INSTRUCTIONS FOR INSTALLING THE 402866 MODIFICATION KIT TO PROVIDE
IMPROVED RIBBON TRACKING FOR MODEL 40 80-COLUMN TRACTOR FEED PRINTER

SPECIFICATION 50836S

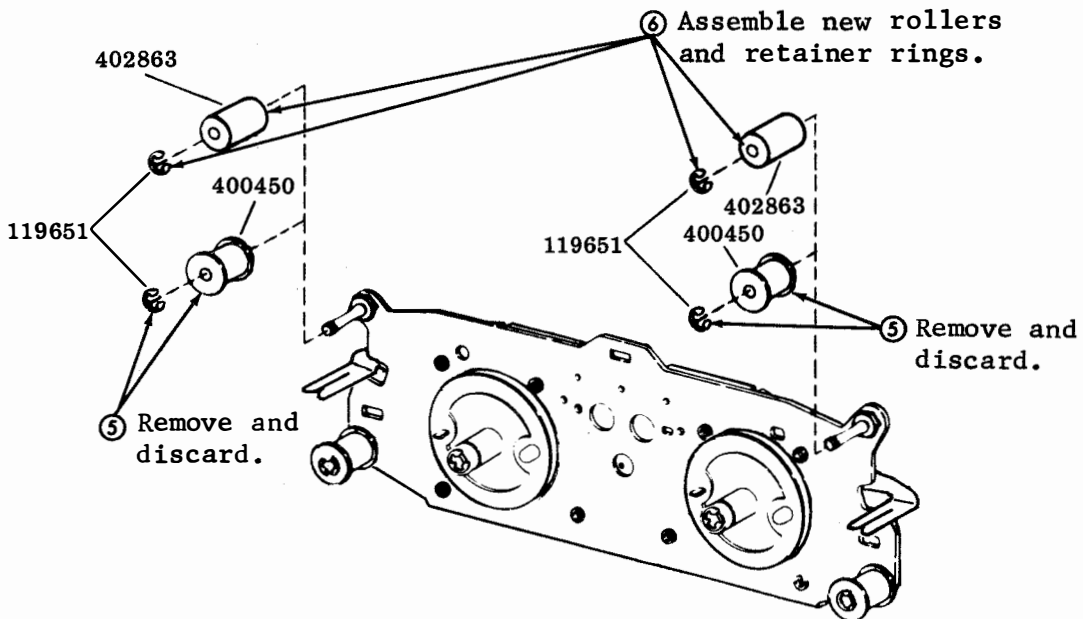
① Set printer in a vertical position with ribbon feed mechanism UP.

② Pull off both ribbon spools. Roll up ribbon and set aside.

④ Remove ribbon feed assembly and drive belt.

③ Remove and retain (3) 184056 screws w/lockwashers.

2.01 Modify ribbon feed assembly:

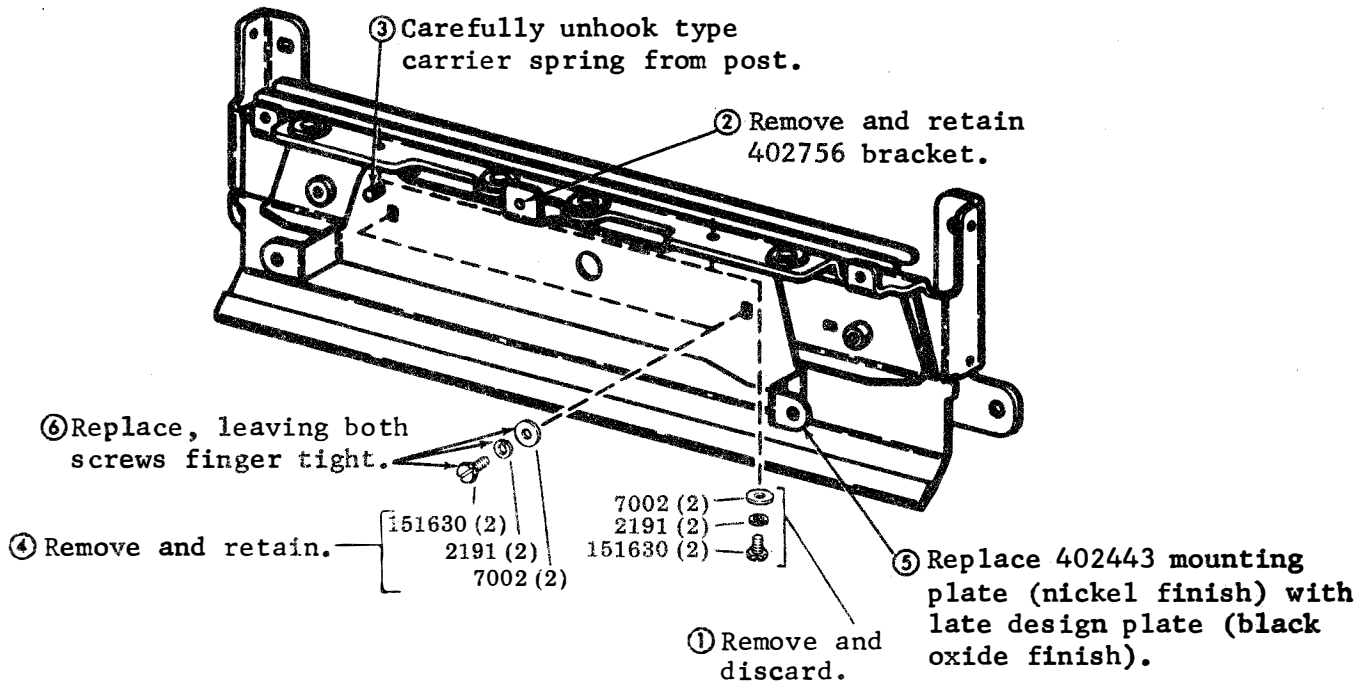
⑥ Assemble new rollers and retainer rings.

⑤ Remove and discard.

⑤ Remove and discard.

2.02 Modify front plate assembly:

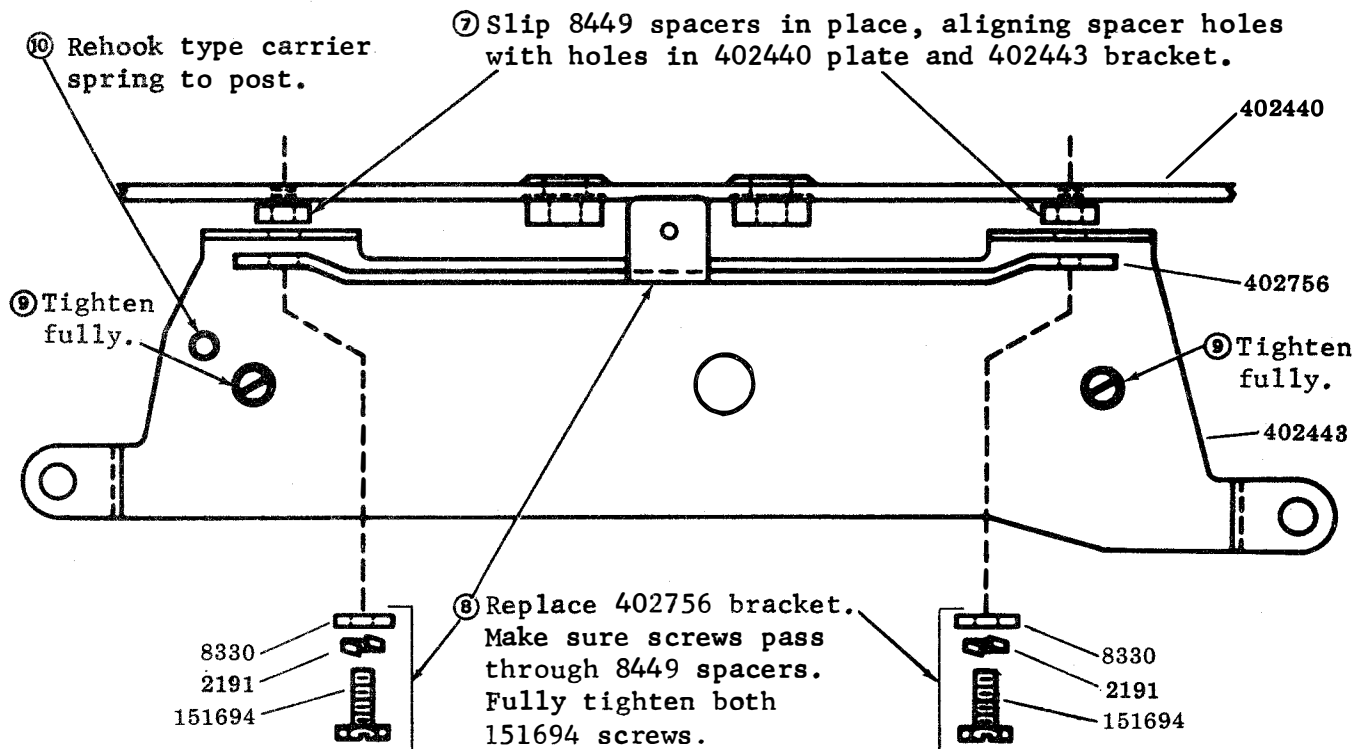
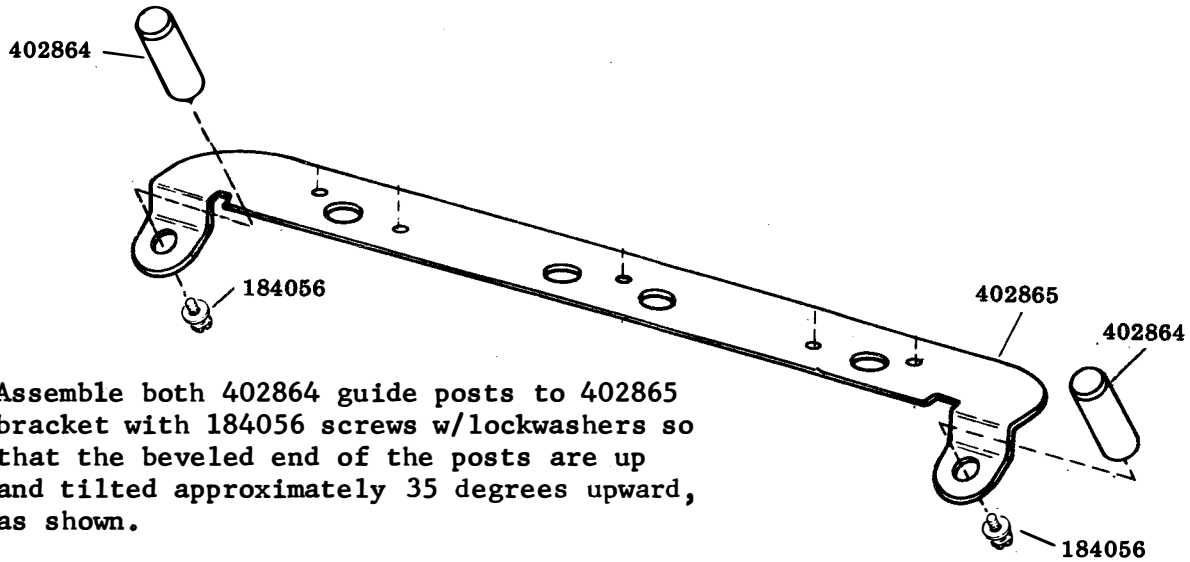
⑪ Replace ribbon feed assembly and drive belt (Steps ④ and ③ of Paragraph 2.01) and make Ribbon Feed Drive Belt Tension adjustment. See 3.01.

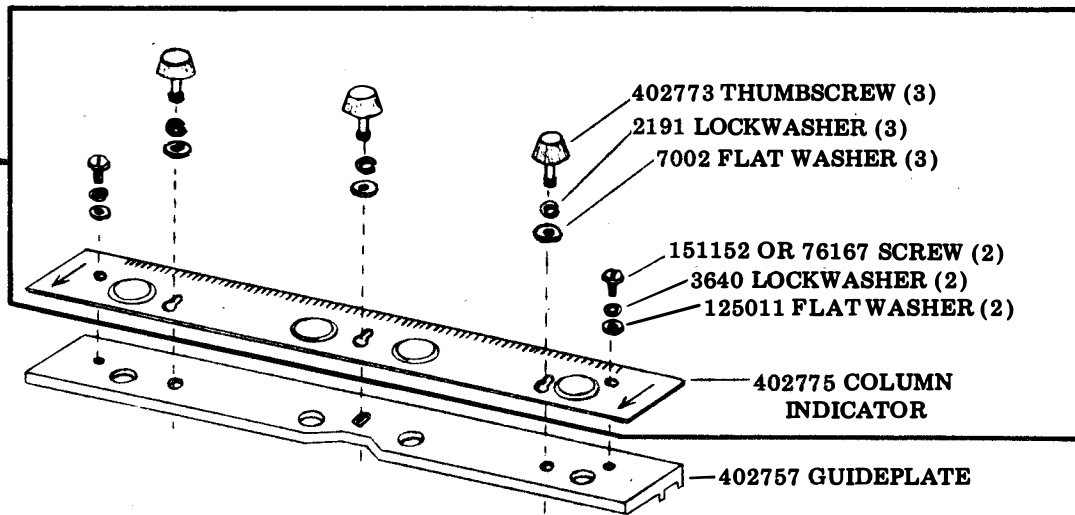
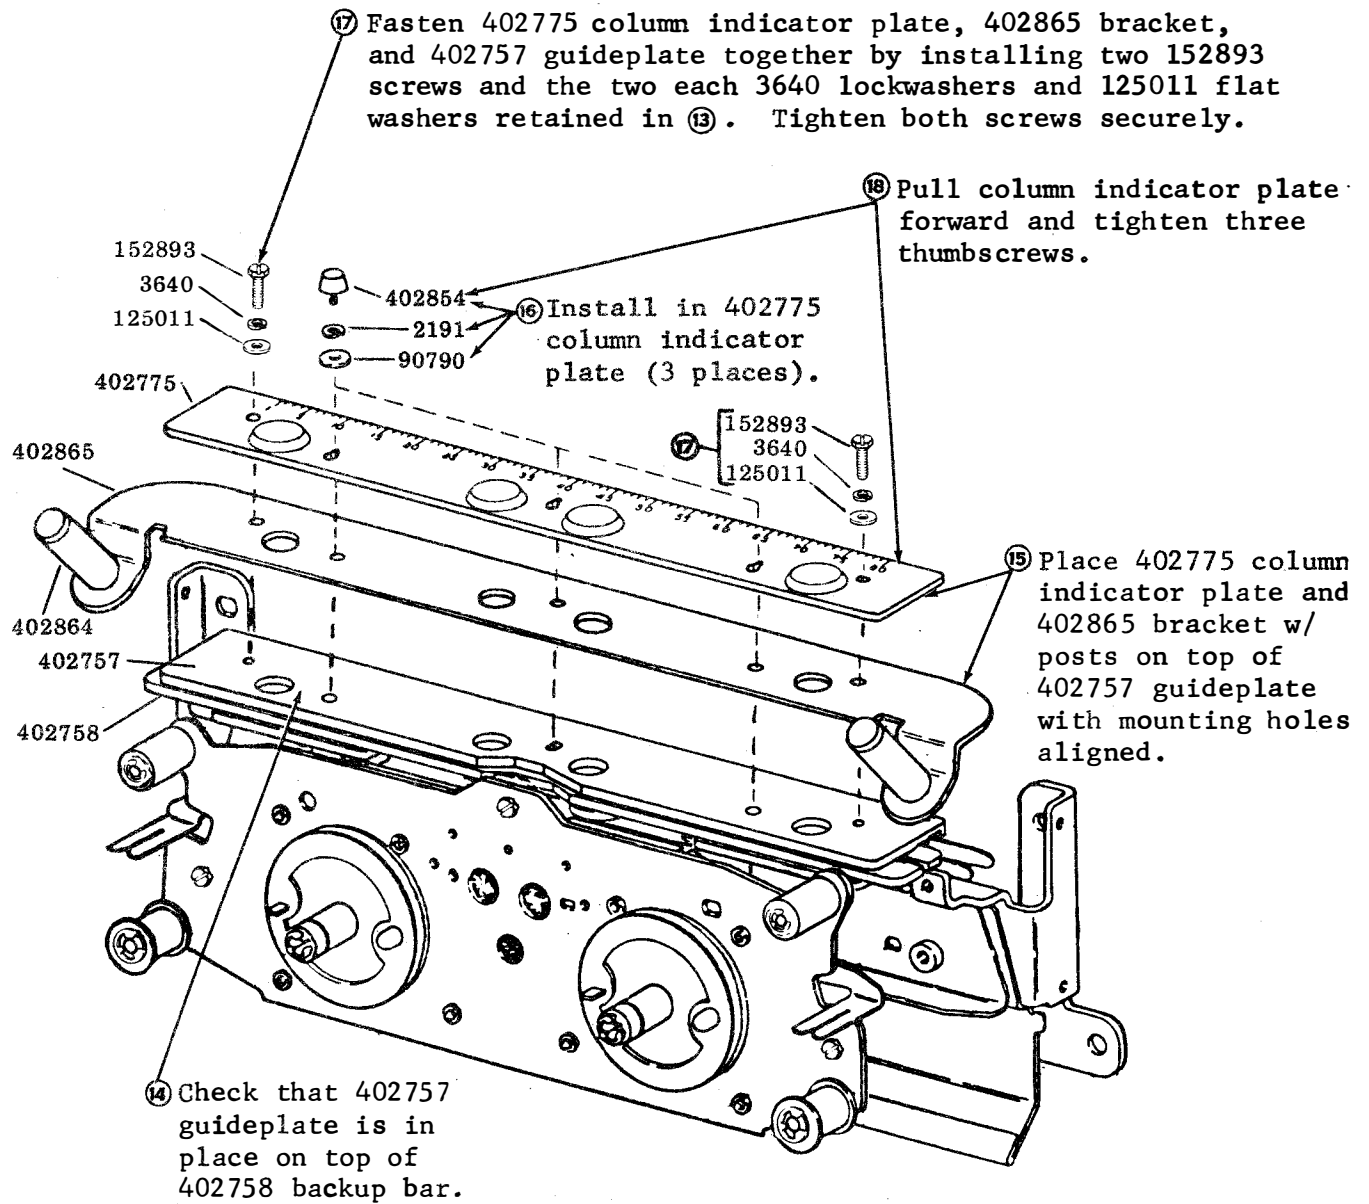
⑫ Assemble both 402864 guide posts to 402865 bracket with 184056 screws w/lockwashers so that the beveled end of the posts are up and tilted approximately 35 degrees upward, as shown.

⑬ Remove all parts inside boxed area, whichever group present. Discard all removed parts except retain (3) 2191 lockwashers, (2) 3640 lockwashers, (2) 125011 flat washers, and the 402775 column indicator plate.

2.03 Modify ribbon guide arm assemblies:

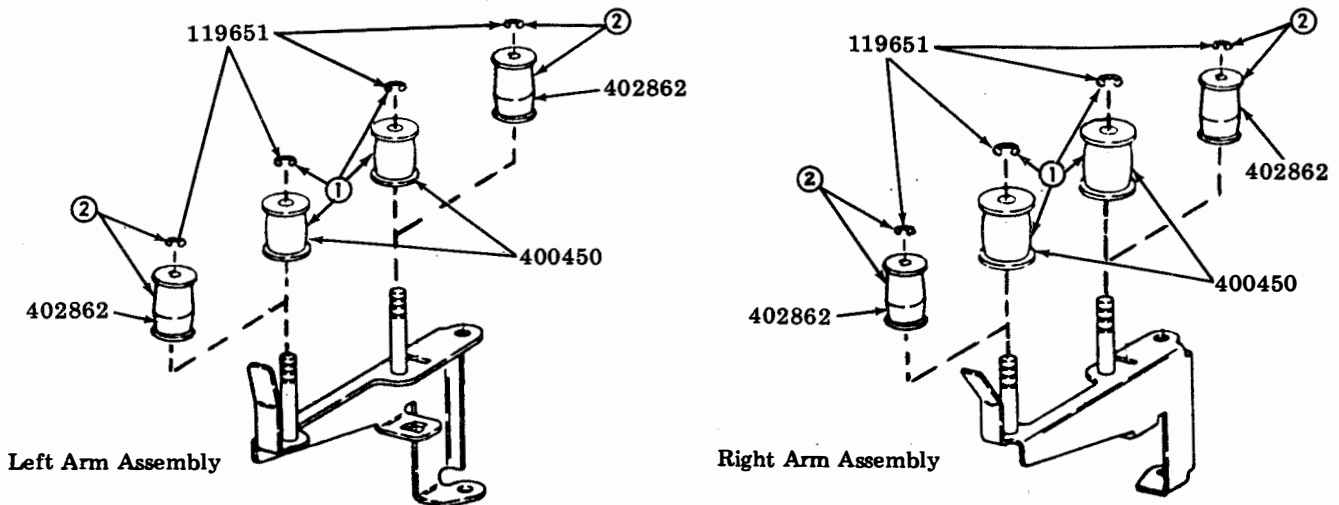
- ① Remove and discard (4) 119651 retaining rings and (4) 400450 ribbon spools.
- ② Install (4) 402862 ribbon spools and (4) 119651 retaining rings. The ribbon spools must be installed with the groove and bulge downward.

2.04 Install new ribbon and instruction tag:

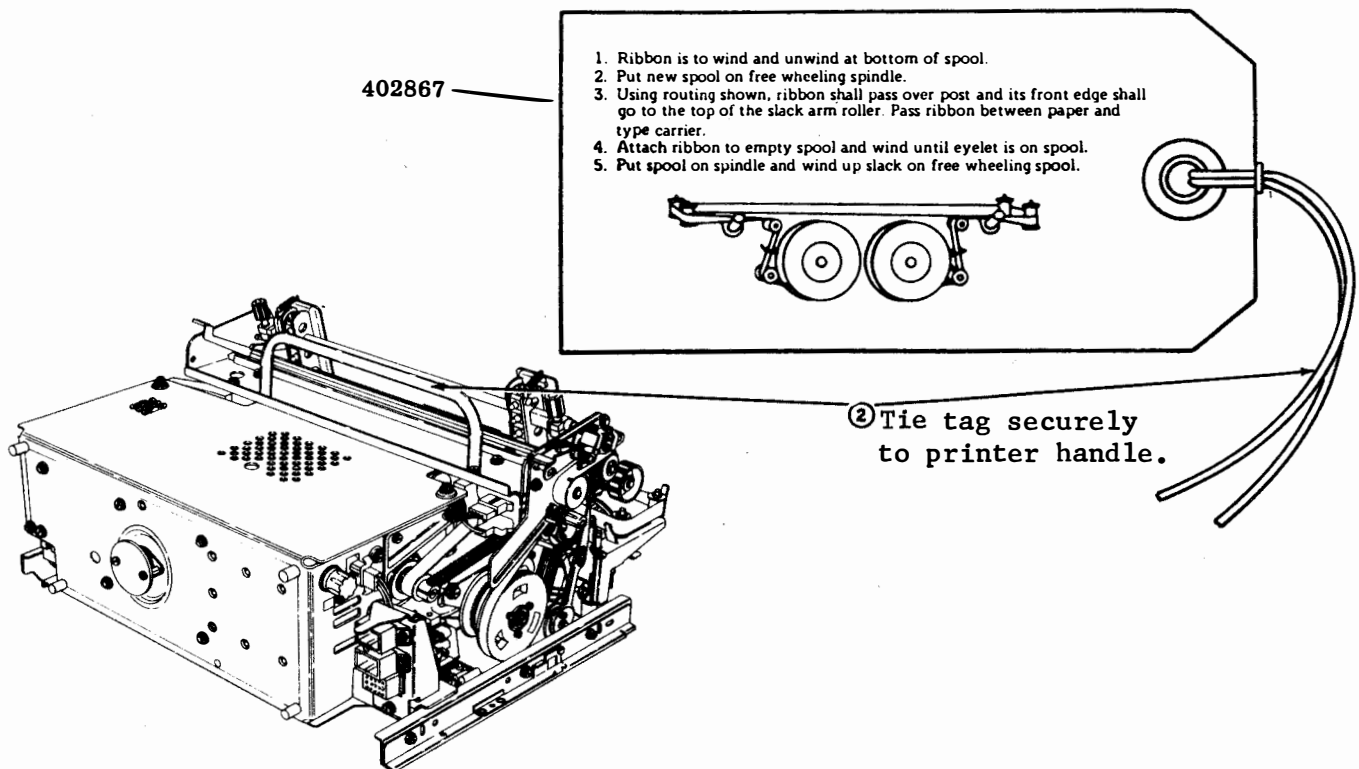
- ① Install new ribbon as detailed on 402867 tag.

3.01 RIBBON FEED DRIVE BELT TENSION

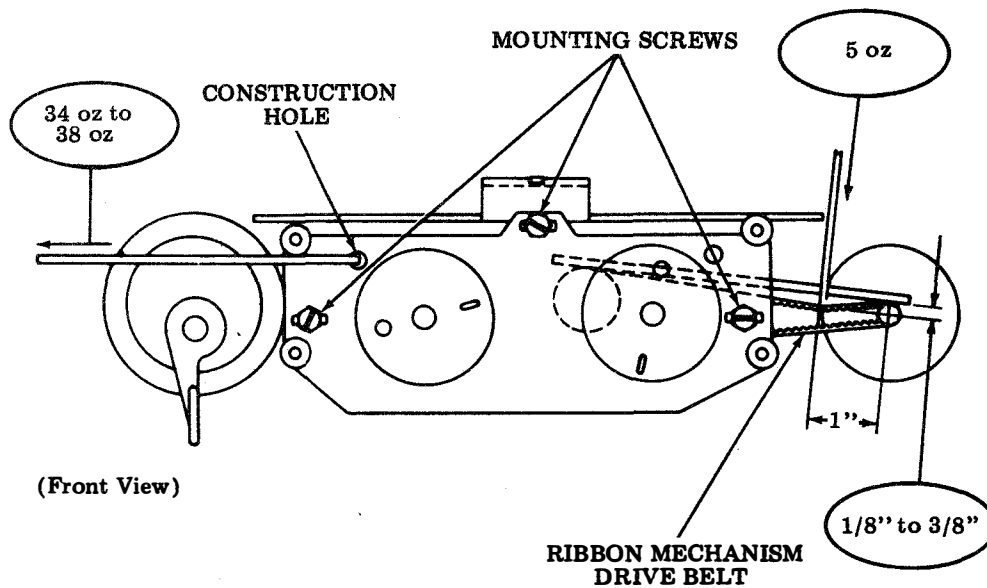
With a force of 5 ounces applied perpendicular to the drive belt approximately 1 inch from right pulley, belt should deflect 1/8 inch to 3/8 inch from a line tangent to both pulleys.

Loosen mounting screws to allow mechanism to move freely to right or left. Pull against construction hole to left with a force of 34 ounces to 38 ounces. Tighten mounting screws with tension applied.

3.02 RIBBON TRACKING

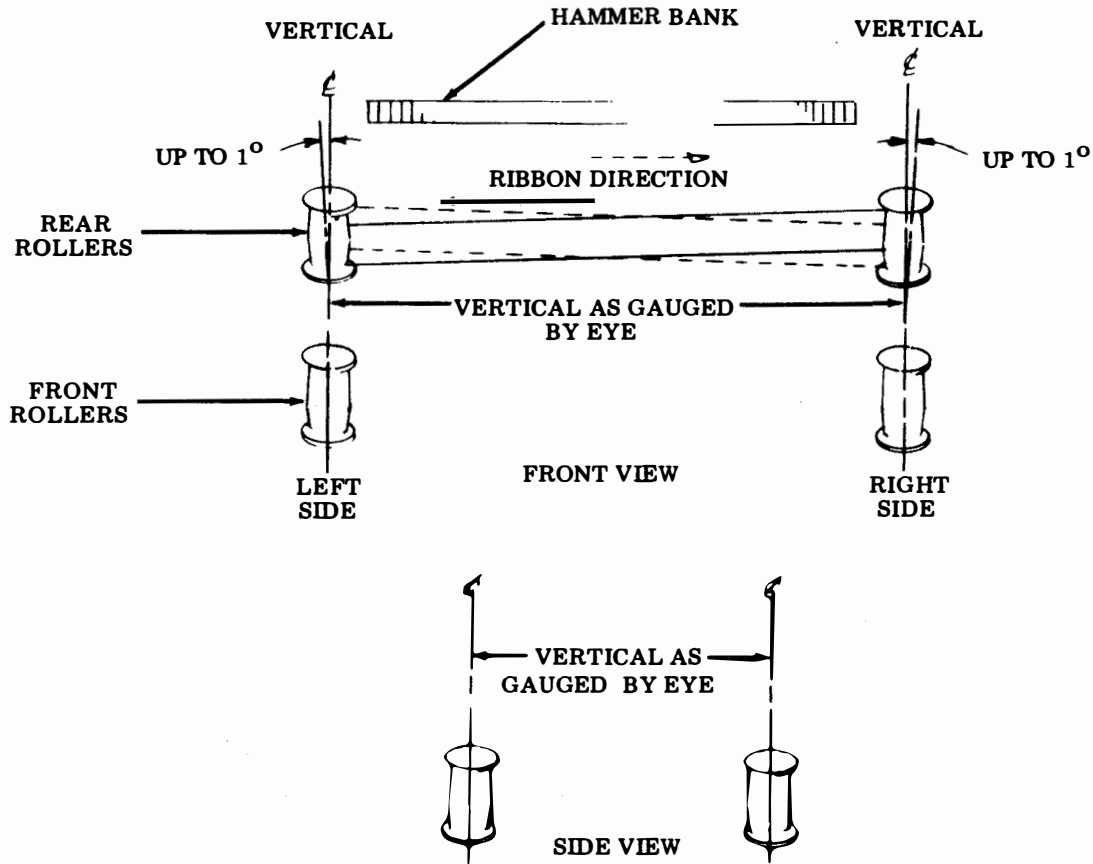
The posts carrying the front roller must be vertical (in reference to the ribbon guide top plate) as gauged by eye. The posts carrying the rear rollers must be vertical in the front to rear direction and the right roller should lean towards the right by a slight amount (less than 1°) and the left roller should lean towards the left by a slight amount (less than 1°).

If rollers do not meet requirement or ribbon is not tracking properly (see Par. 5) the vertical alignment of roller posts may be refined. To lower the ribbon track increase the amount the rear rollers lean outwards. (The right roller to the right and the left roller to the left.) To raise the ribbon track do the opposite. Caution must be used not to over adjust. A 1/4 inch spin-tight socket wrench will slip over the roller post and can be used for adjusting.
